Vastern Court, Caversham Road, Reading: 328974

Planning Application number: 200328/OUT

NATURAL ENVIRONMENT OFFICER RESPONSE TO REVISED I33 'VASTERN ROAD SECTIONS' DATED 11 JULY 2022 (RECEIVED 14/7/22) - COMPARISON WITH ID33 DATED 6 MAY 2022.

Figure 2. Plan of Vastern Road boundary showing line of trees planted along a line 2.5m from the kerb line.

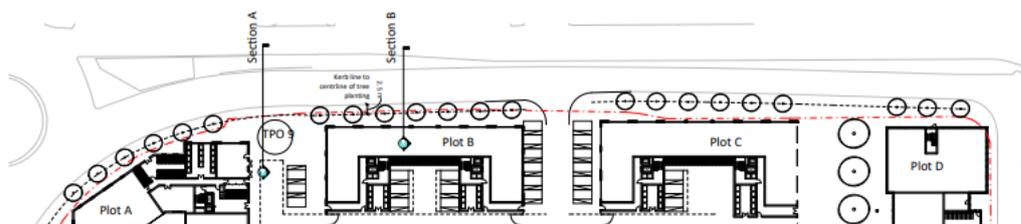
The services are not labelled on Figure 2, but it is assumed that the appellant has accepted the existence of the services highlighted in ID39 ‘Note on Vastern Road tree planting’.

It can be seen from the position of these that the indicative tree planting is now considerably more constrained than that indicated on the Original Figure 2 and differs to that shown on the Illustrative Landscape Masterplan within Section 7.8 of the September 2021 Design and Access Statement (CD 1.55). In relation to the tree planting along the Vastern Road frontage, Figure 3 limits this to the frontages of Plots C & D, entirely on Highways land, and limited to ‘a line 1.0m from the kerb line where services permit’. The appellant is confirming that tree planting could only potentially be accommodated in this location and within the limited width (root space). This, however, does not address or take into account the matter of canopy conflict discussed during the Round Table discussion, i.e. to meet with the statutory requirement, the lowest branches would have to be 5.5m above the road at the time of planting - this is dealt with on page 1 of ID39. In addition, no confirmation is provided that the utility providers would be content with a tree planted in such close proximity to their service route (reference the last paragraph of ID39) or that a suitably sized soil volume could be provided for the required large canopy trees.

The appellant has therefore not demonstrated that any tree planting along the Vastern Road frontage would be feasible within the confines of the proposed parameters.

Figure 7. Section B adjacent to Plot B
Showing where street trees can be planted in a 2m minimum zone adjacent to the carriageway, with a 2m cycleway and 2m footpath running adjacent to the building faces.

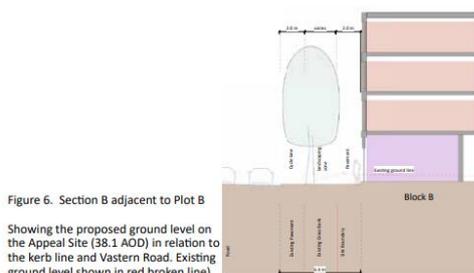
Due to the addition of a Figure in 1.0, figure 5 (of original ID33) is now Figure 6 and Figure 6 is now Figure 7. Figure 7 has been amended to account for the revised indicative tree planting - the original version (below, left) and revised version (below, right) are provided for comparison:

No changes have been made to address the responses given in ID44 & ID45 to the original ID33 - Figures 4, 5 & 6 (previously 3, 4 & 5) remain unchanged.

It is worth noting that the retention of TPO 09, if even proven to be feasible, is based on an amended footprint for Plot A, so is contrary to the Parameters Plan Revision P2 which the Inspector is being asked to approve.
